APPLICATION FOR ZONING CHANGE

**OVERLAY DISTRICT  
SITE PLAN APPLICATION**

FOOD LION, INC. SITE #50a  
F.M. 740 @ F.M. 3097  
Rockwall County  
Rockwall, Texas

Preliminary Plat	
Steger Retail Addition	
James Smith Survey, Abstract No. 200	
City of Rockwall	
Rockwall County, Texas	
Client : JEMtex Development No. 50a, Inc. 1303 Walnut Hill Lane Ste. 130 Irving, Texas 75038 (214) 550-8221	Owner : Estate of O.L. Steger, Jr. & Emily Sue Whitehead C/O Lakeside National Bank P.O. Box 9 Rockwall, Texas 75087

JOB NO. 91-06  
DATE 3-19-91  
DRAWN M.T.B.  
CHK J.D.H.  
SHEET: A-3  
OF 19  
EXTERIOR  
ELEVATIONS  
3390-DB 1Z

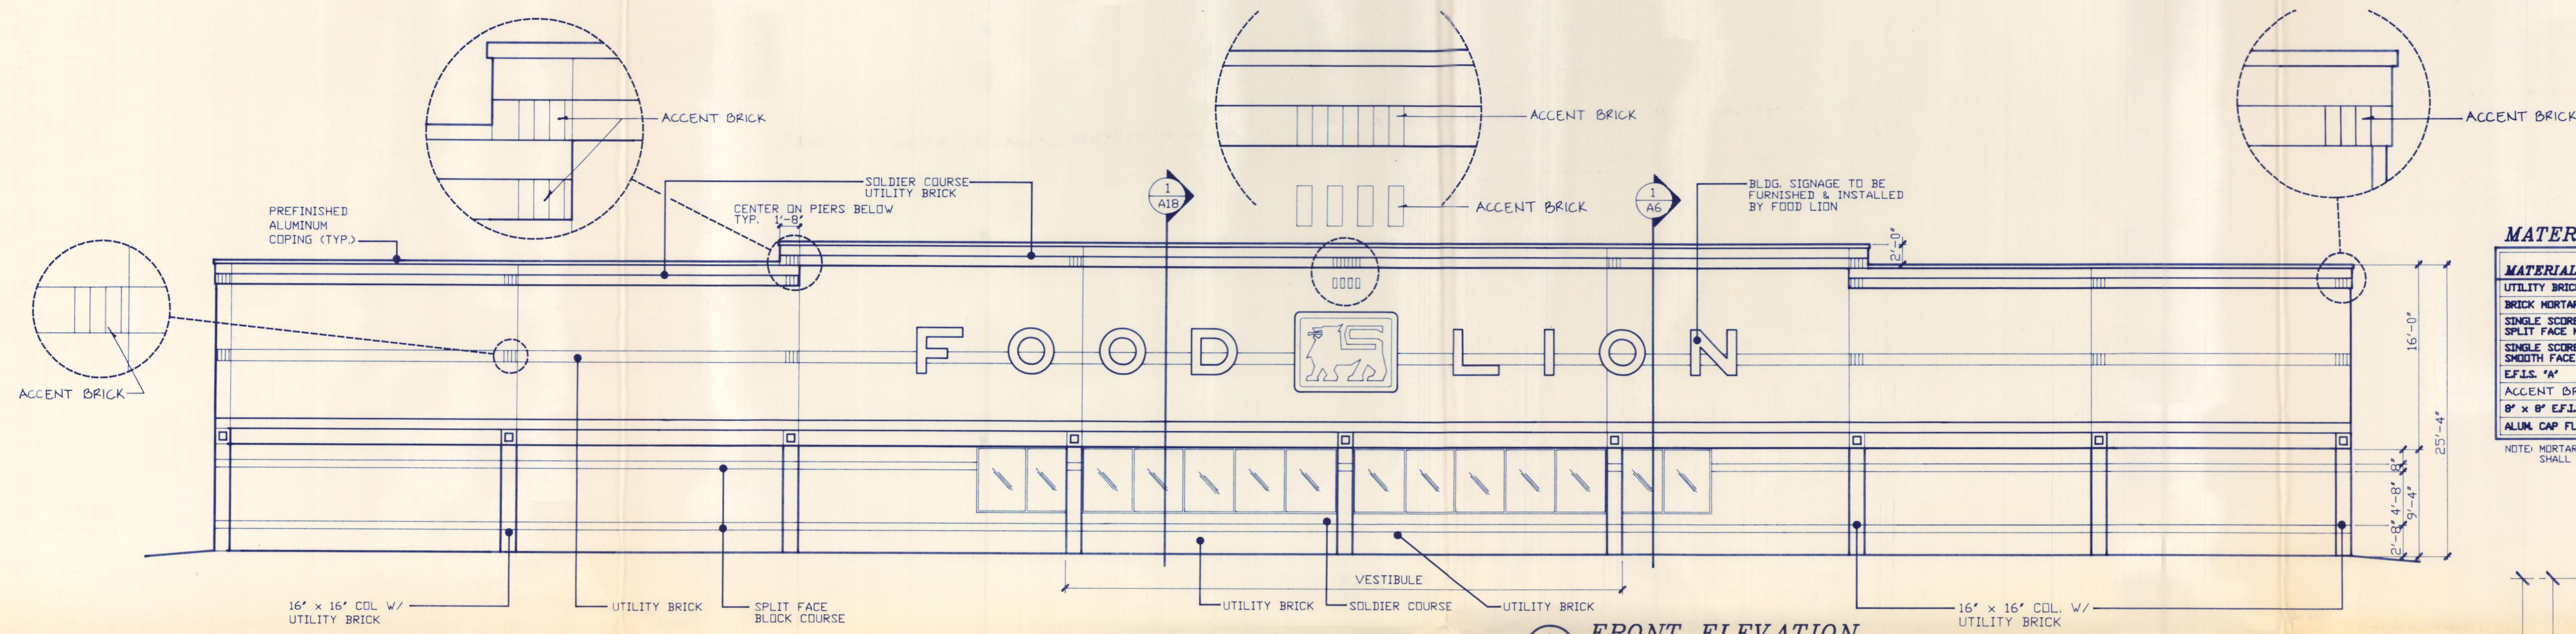
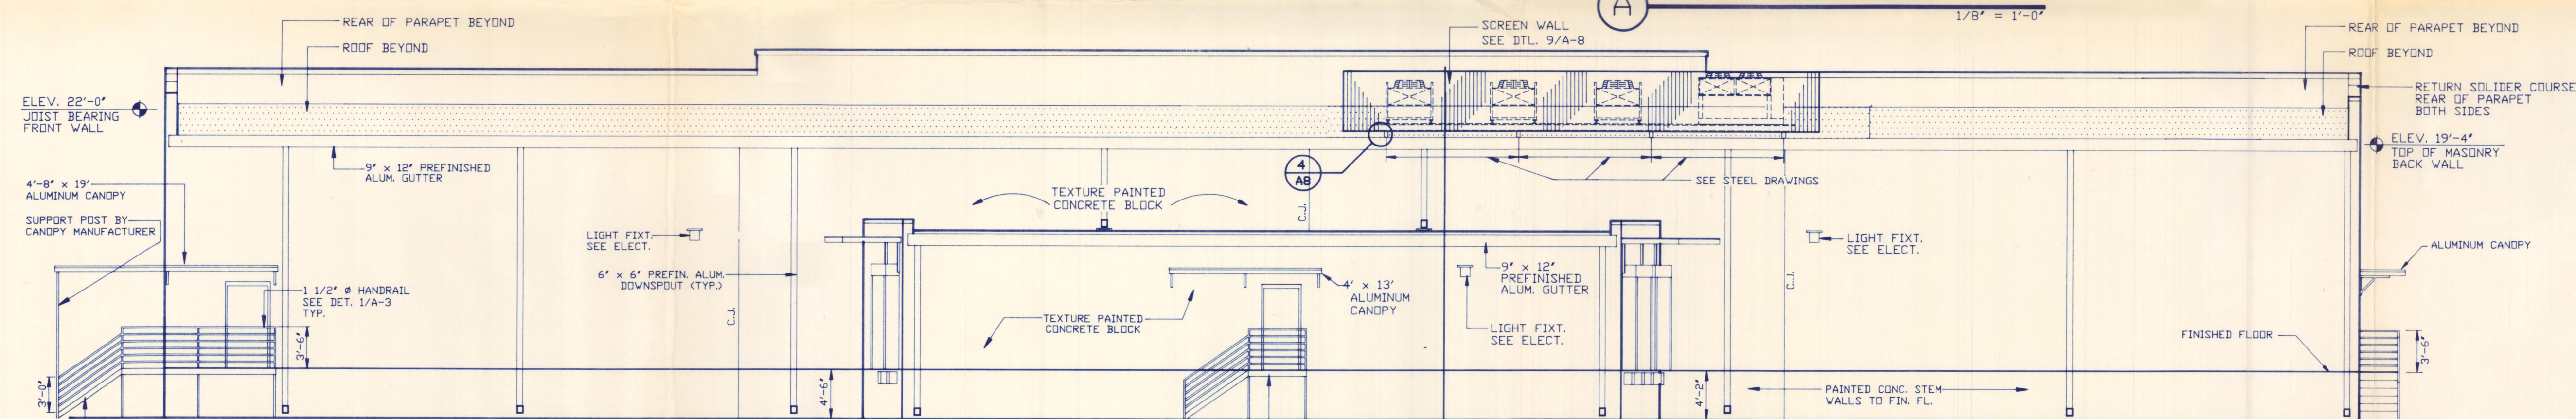
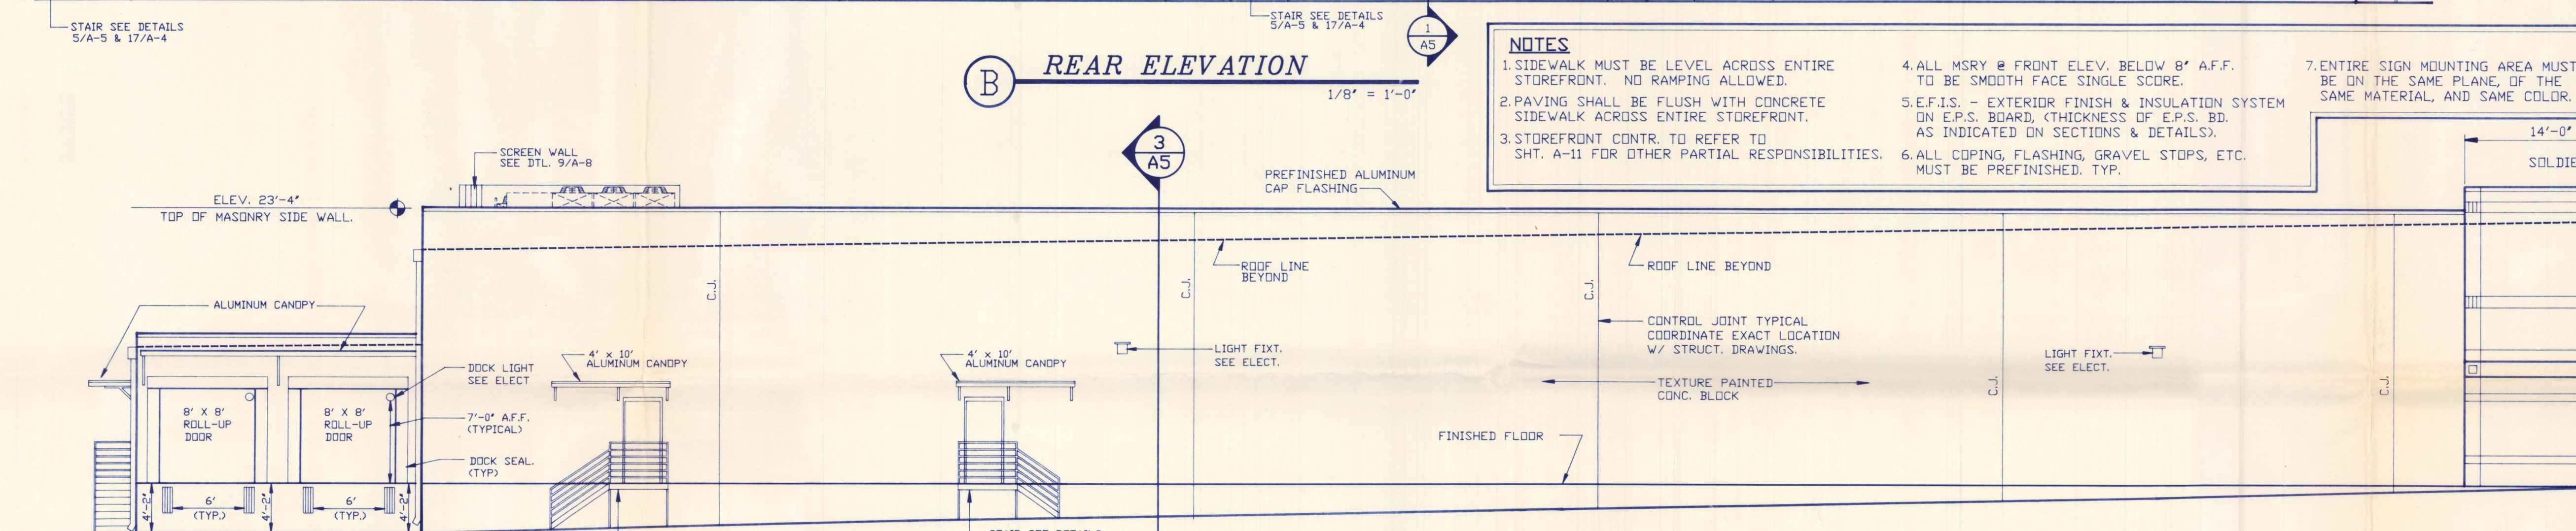
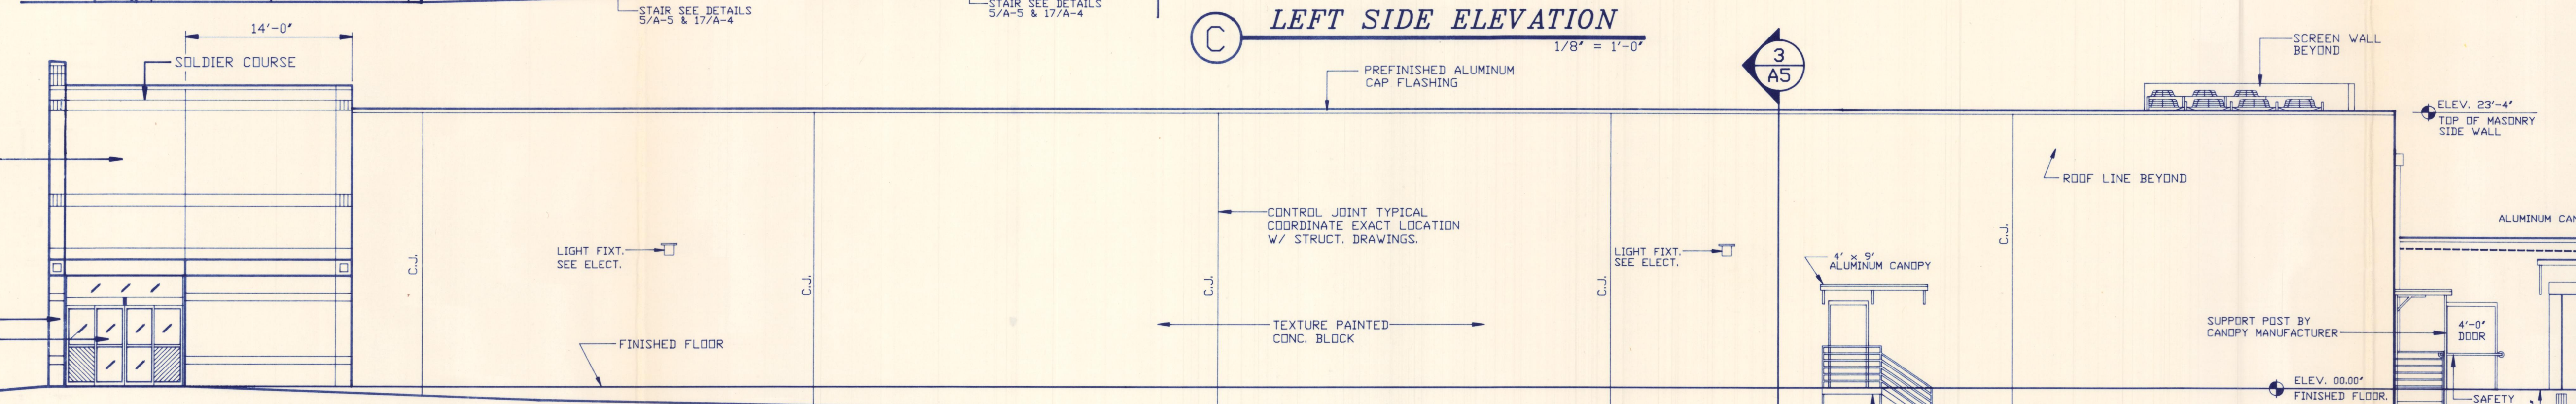
add variations & color to top &  
Bottom on front elevations

add Brick to 8+18 on both sides

1. The building facade in front is not like the facade approved at the other location. The previous location included a taller front parapet with wrap around brick to give the facade more substance. The Commission will want to know why this change was made. One of the purposes of the wrap around on the sides was to help screen the roof mounted deli utility equipment. Will this equipment be used in this building?

2. What type of roof mount screen will be used around the utility equipment to the rear and will that screen be used on three sides?
3. The previous plan included brick around all four sides of the building. This location will not have the visibility of the previous location but the sides will be totally visible until there is additional development. Even when additional development occurs some of the sides will continue to be visible. The Commission expressed some concern about this issue. There is additionally no guarantee that future buildings will be located adjacent to this building. The Commission also expressed concern about the use of concrete block. There was some discussion about a stucco type paint material that might be used to surface the block. You need to be prepared to discuss this issue at the Architectural Review meeting as I am sure that it will be raised.

4. Please identify the material for the screens around the dumpster locations. It generally should match the material on the main structure.
5. Will the stairs in the rear be of the same bronze color as the coping along the top of the building? They were planned to match under the previous plan.

6. The front wall of the entry vestibule is on the same vertical plane as the front facade. The remainder of the front facade is supported to either side of the vestibule by brick piers. This provides for a covered sidewalk 12'-0" wide at either side of the entry vestibule.
